Regulatory Division
199404532 (IP-BB)
Modification #5

Reference is made to the Department of the Army Permit, numbered 199404532, that authorized certain works for the Everglades Construction Project. The permit was issued to the South Florida Water Management District on March 13, 1997. This letter hereby modifies that permit.

Hydroperiod Restoration
for
Water Conservation Area 2A

SITE PLAN FOR G-336 F,G,H,I,J,K

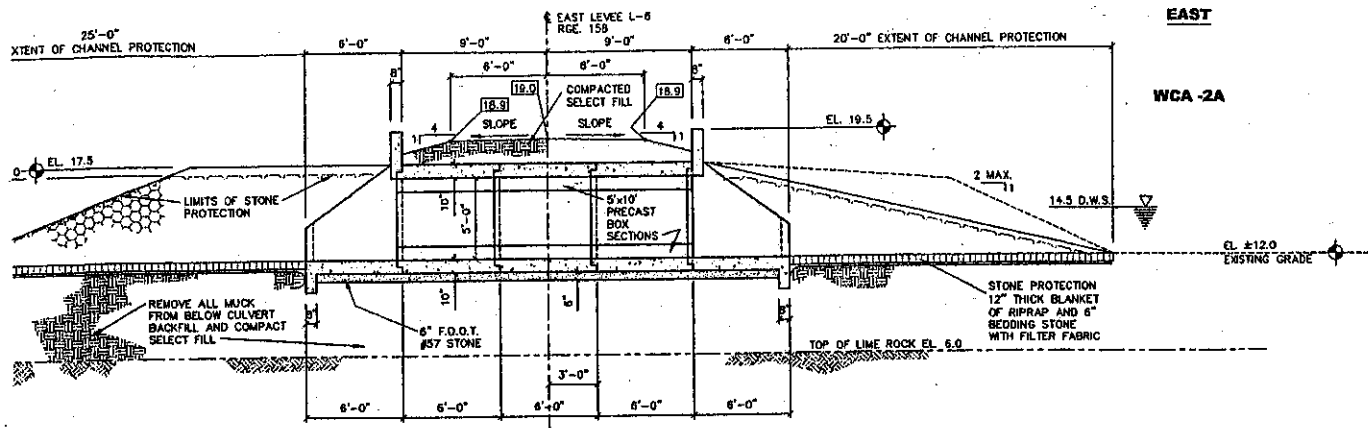
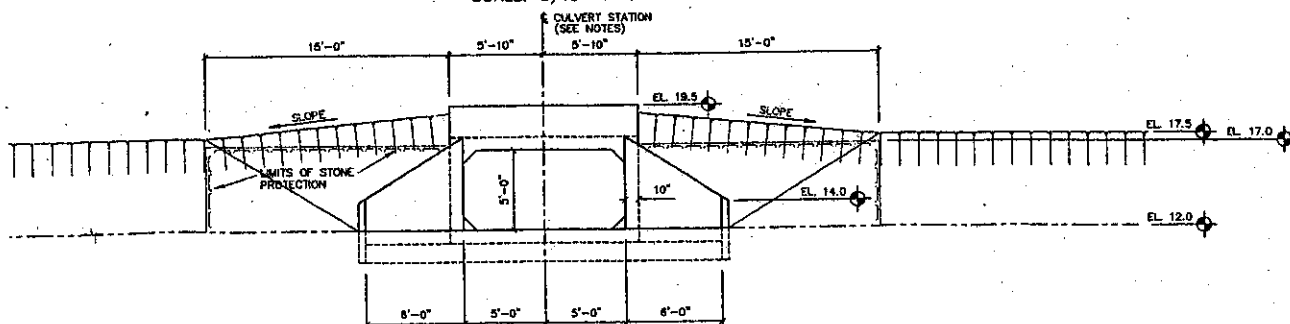
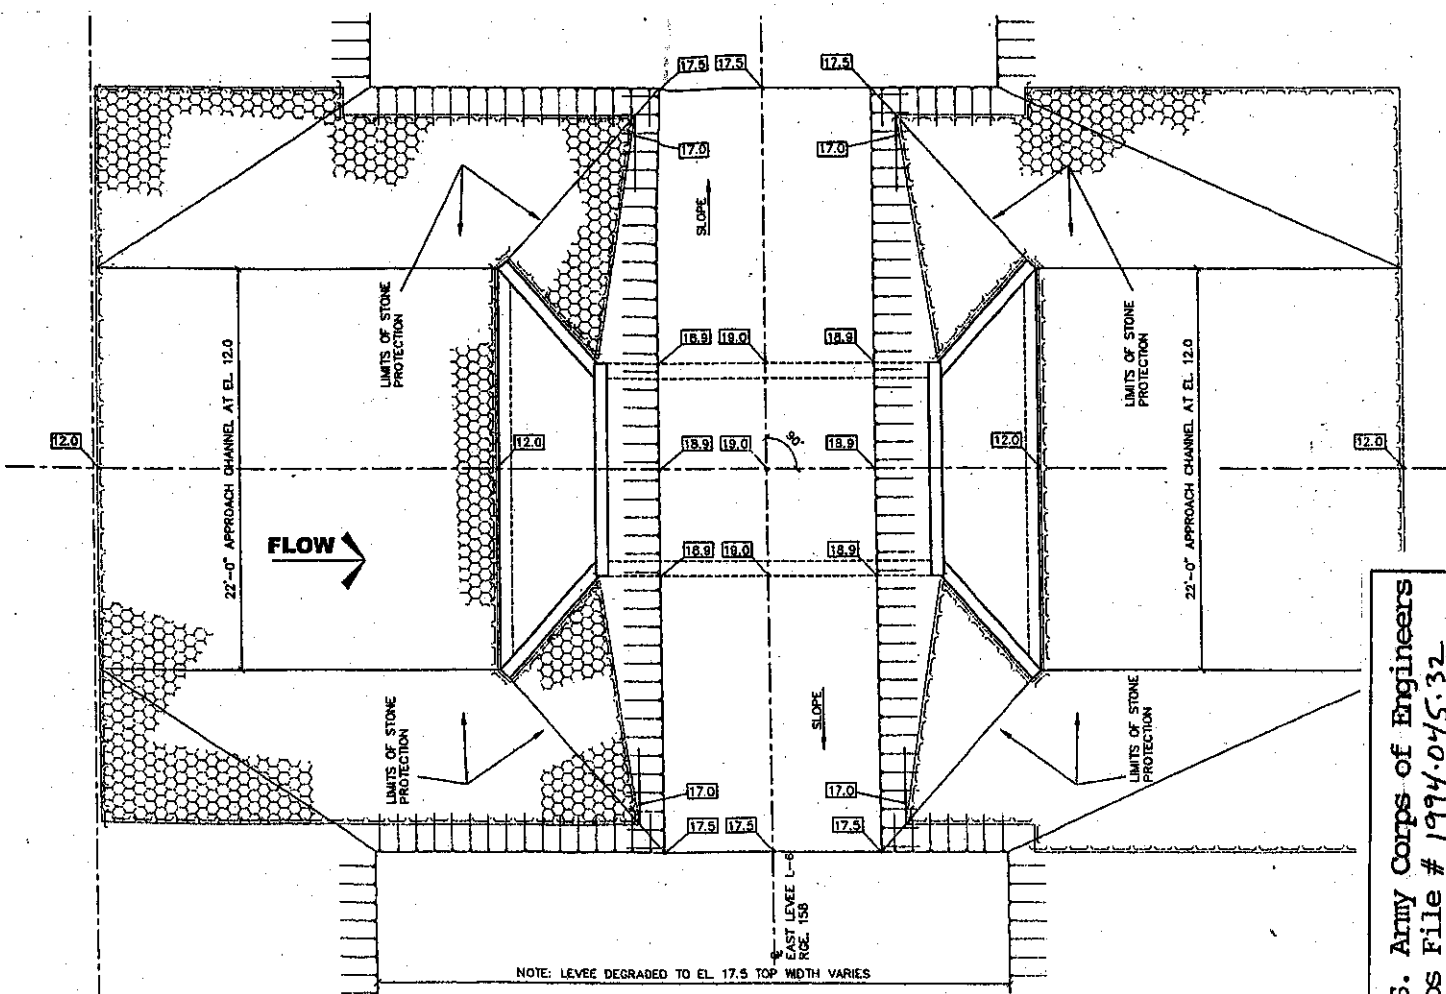
The enclosed drawing page 18 hereby replaces the existing page 18 and drawing page 20A of 60 is hereby added to the permit instrument to include work related the construction of box culverts at 6 locations along East Levee L-6.

At 6 locations where East Levee L-6 is degraded, at Stations 438+00, 558+00, 478+00, 498+00, 510+00 and 542+00 where Station 0+00 is approximately at Pump Station S-7, activities include placement of fill related to the construction of 6 box culverts as described by the drawing on page 20A.
